Our Reference: ET15-027  
DSC Reference: MCU 1288-20016

**RE: RESPONSE TO COUNCIL INFORMATION REQUEST**

**APPLICATION FOR MATERIAL CHANGE OF USE-PRELIMINARY APPROVAL UNDER SECTION 241 OF THE SUSTAINABLE PLANNING ACT 2009, FOR STAGING SELF ASSESSABLE AND CODE ASSESSABLE DEVELOPMENT, IN ACCORDANCE WITH A PRECINCT PLAN, A STAGING PLAN AND OTHER SUPPORTING PLANS, ON LAND LOCATED IN THE PORT DOUGLAS WATERFRONT NORTH PLANNING AREA, KNOWN AS THE REEF MARINA SITE.**

## Staging Plan

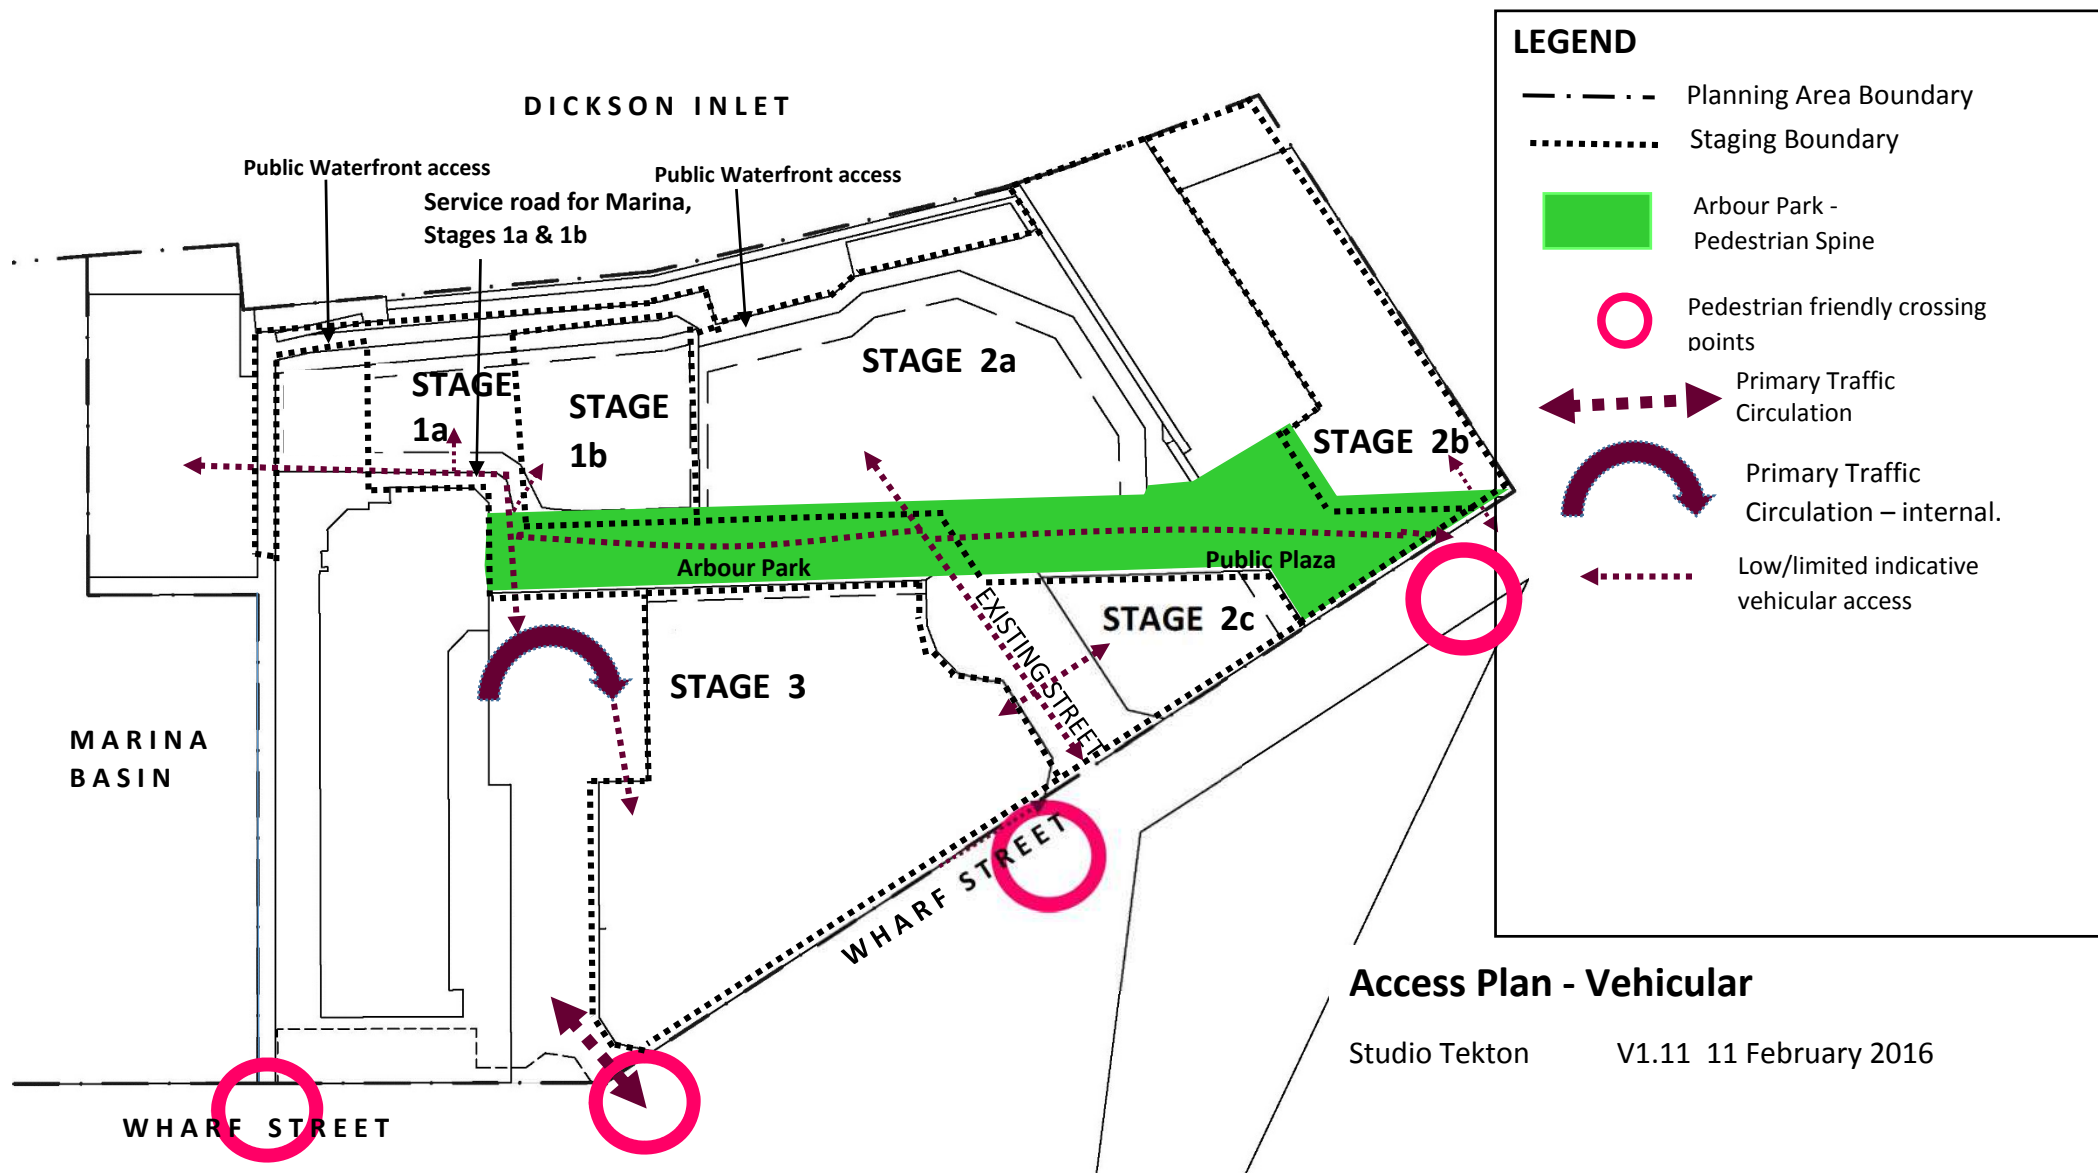
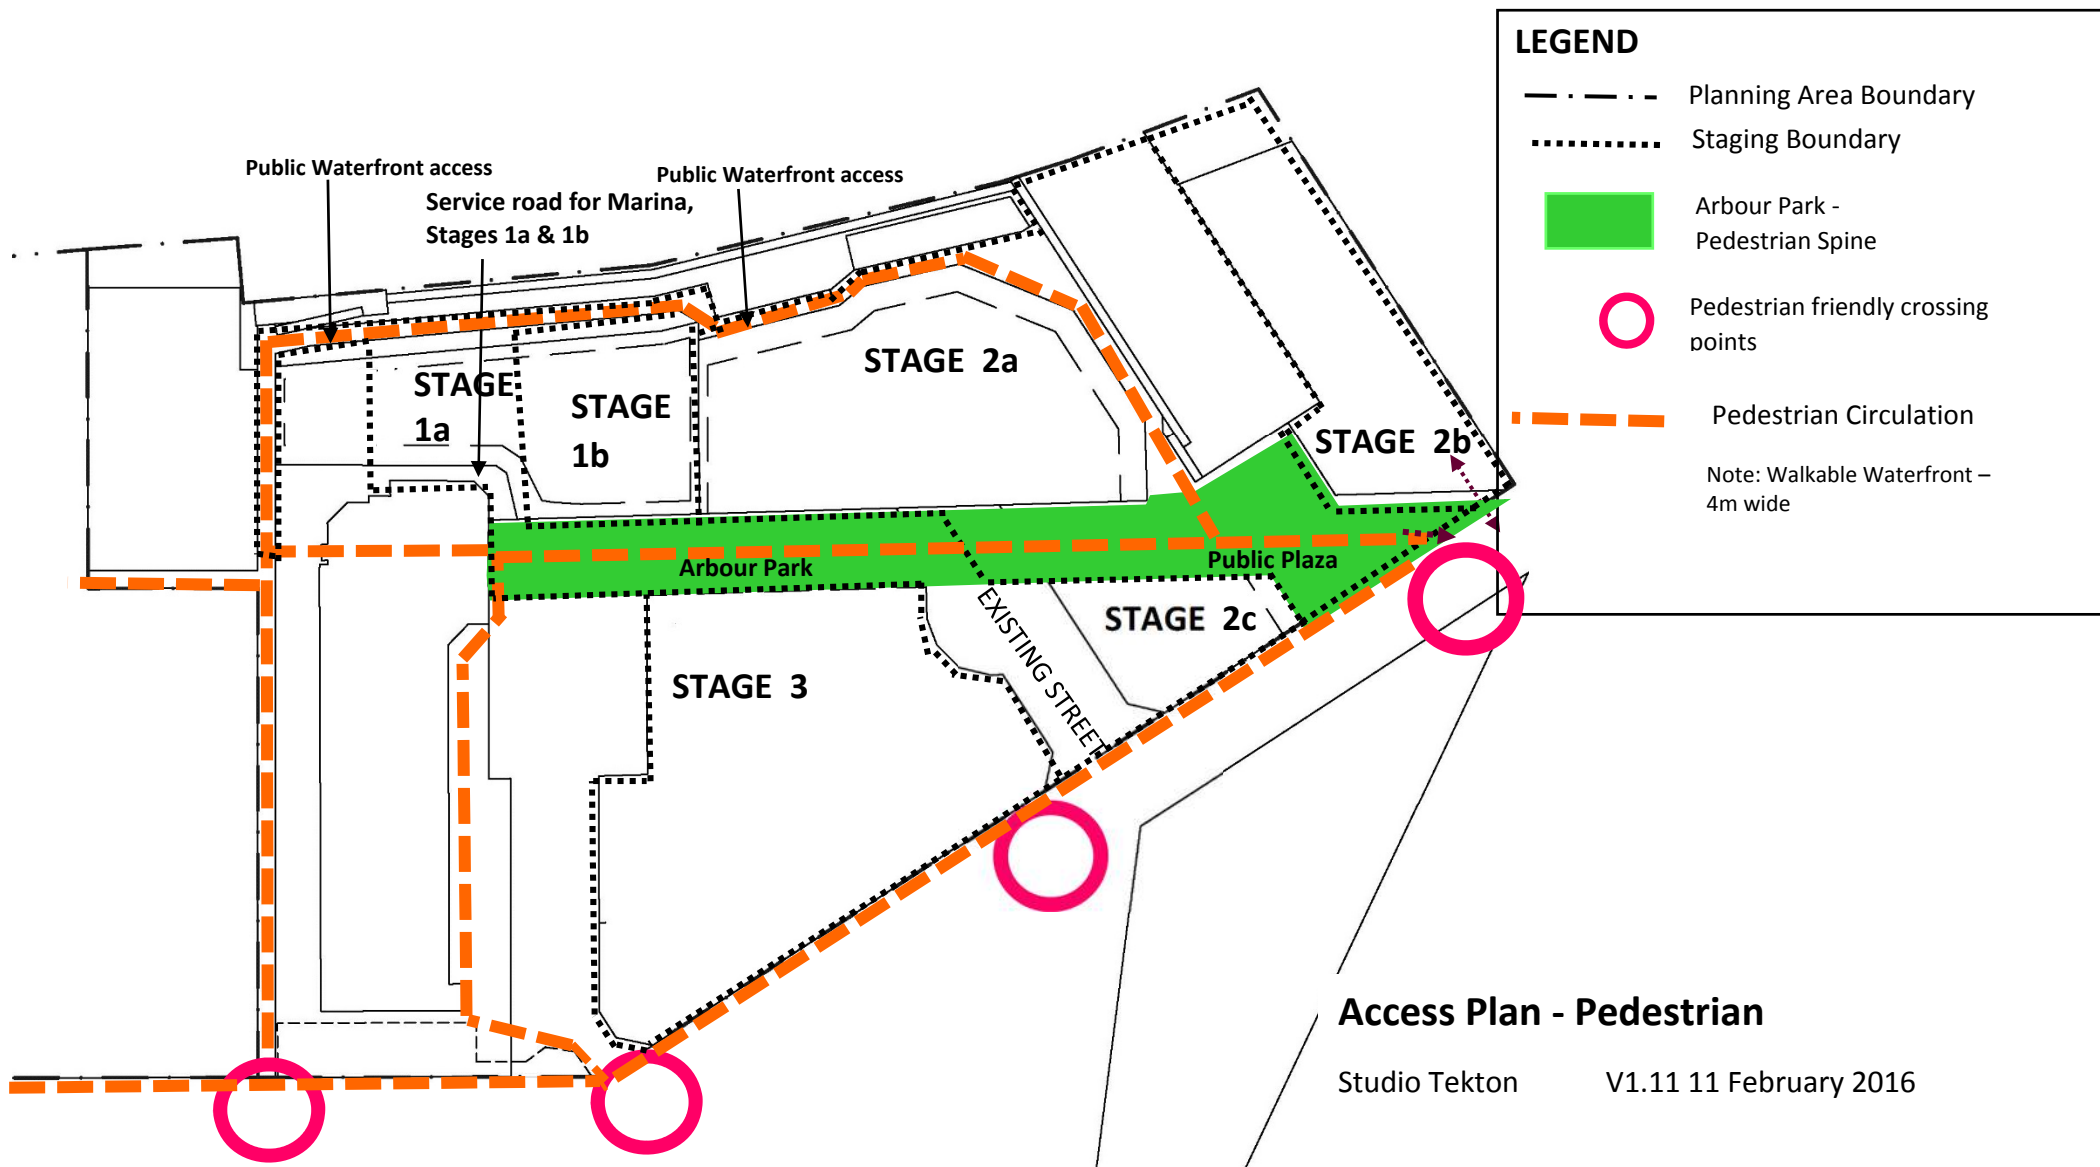
*Item 1- request for the precinct plan and staging plan to be aligned.*

Following those discussions the precinct plan and the staging plan have been amended so that the numbering of the precincts and the proposed staging align and the boundaries of the precincts and the boundaries of each stage of the redevelopment are clearly identified on the plans.

Following changes in the numbering of the Precincts the following applies:

<b>LODGED WITH APPLICATION FOR PRELIMINARY APPROVAL, DATED 18 JANUARY, 2016</b>	<b>LODGED WITH TRM RESPONSE TO COUNCIL INFORMATION REQUEST, DATED 11 FEBRUARY, 2016</b>
PRECINCT 1 >>>>>>>>	PRECINCT 4

PRECINCT 2 >>>>>>>>>	PRECINCT 1
PRECINCT 3 >>>>>>>>>	PRECINCT 2
PRECINCT 4 >>>>>>>>>	PRECINCT 3
PRECINCT 5 > (no change)	PRECINCT 5

## Access Plan - Pedestrian

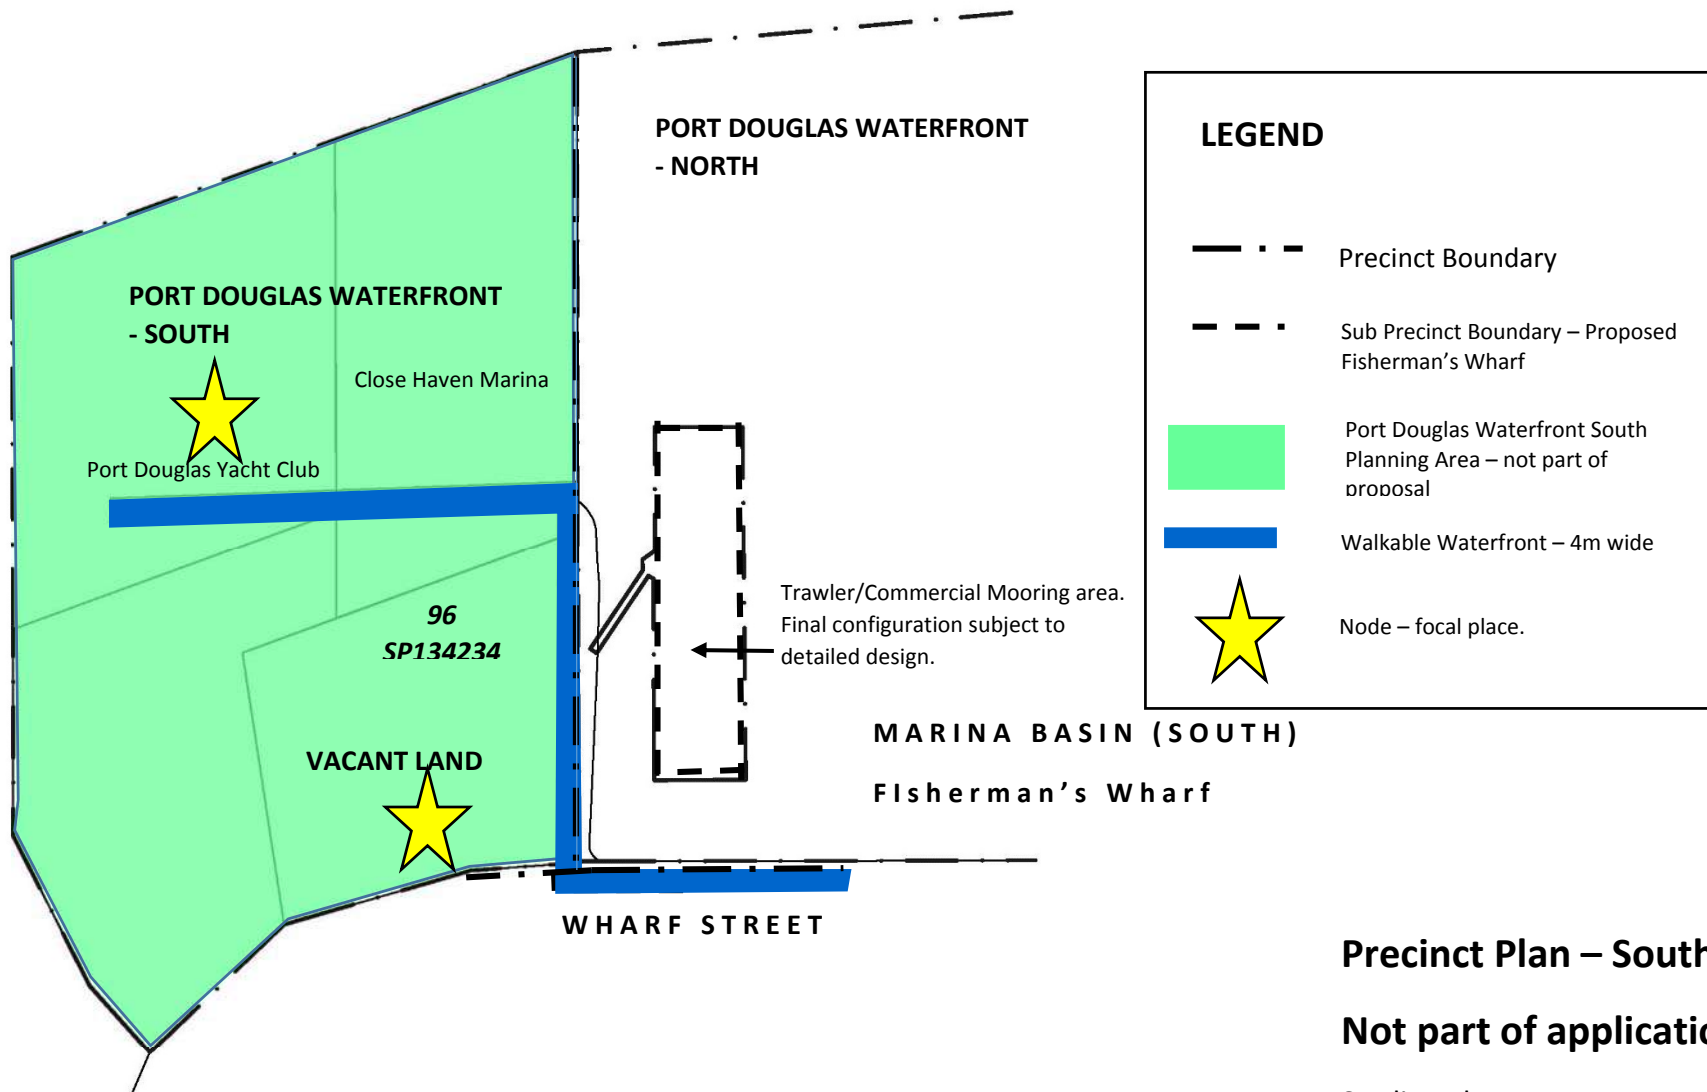
*Item 2 - request that the access plan be simplified and reviewed in order to demonstrate that it supports the proposed staging.*

Access Plan – Pedestrian, shows the Arbour Park pedestrian spine and the pedestrian circulation and connections through, around and within the site and in particular, along the waterfront, via a 4 metre wide boardwalk.

The staging plan and the access plans demonstrate that vehicular and pedestrian circulation can be well managed during the staging of the redevelopment.
